MODEL: C2

SUBJECT: CHASSIS PDM POWER CABLE CHAFING

DATE: JUNE 29, 2012

BULLETIN: 13

FIGURE 1

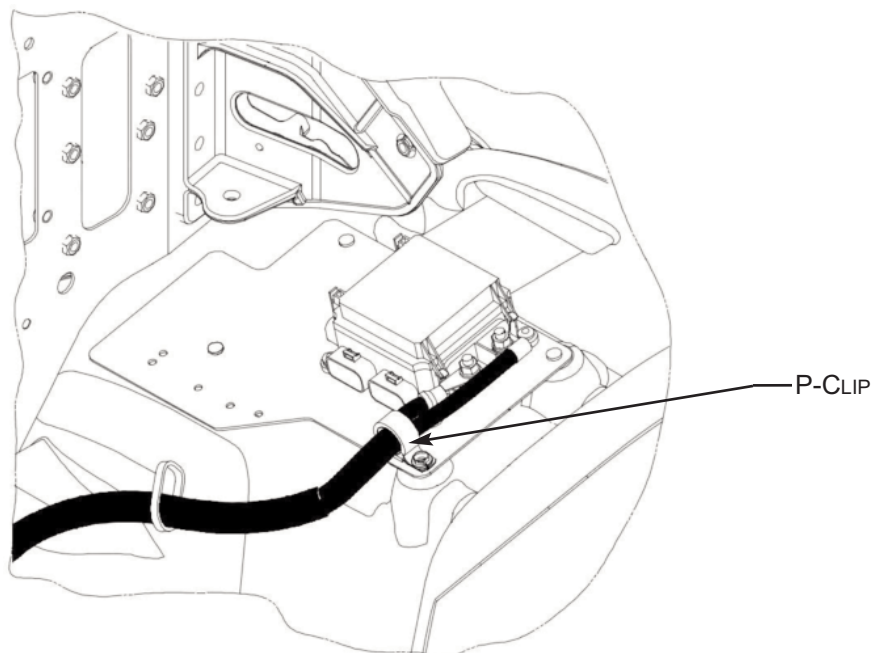
Inspection: Check the unit for the presence of a P-Clip as shown in Figure 1. If P-Clip is present, no further action is required.

FIGURE 3

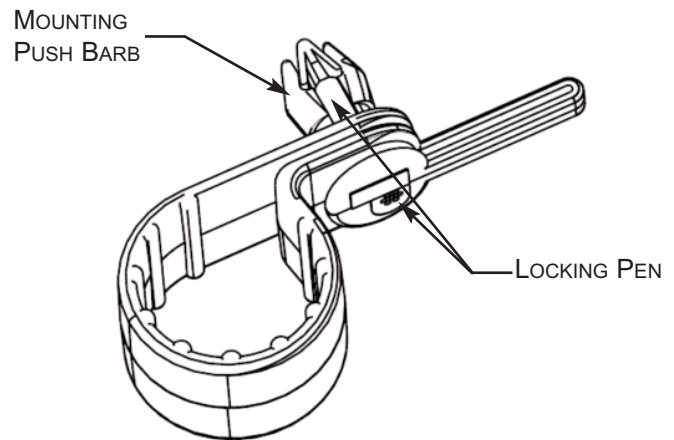
7. Locate the unused hole in the PDM mounting plate close to the power cable. **Figure 3**
8. Open the P-Clip (TBB 61480924) and install around the chassis PDM power cable that is closest to the unused hole. **Figure 4**
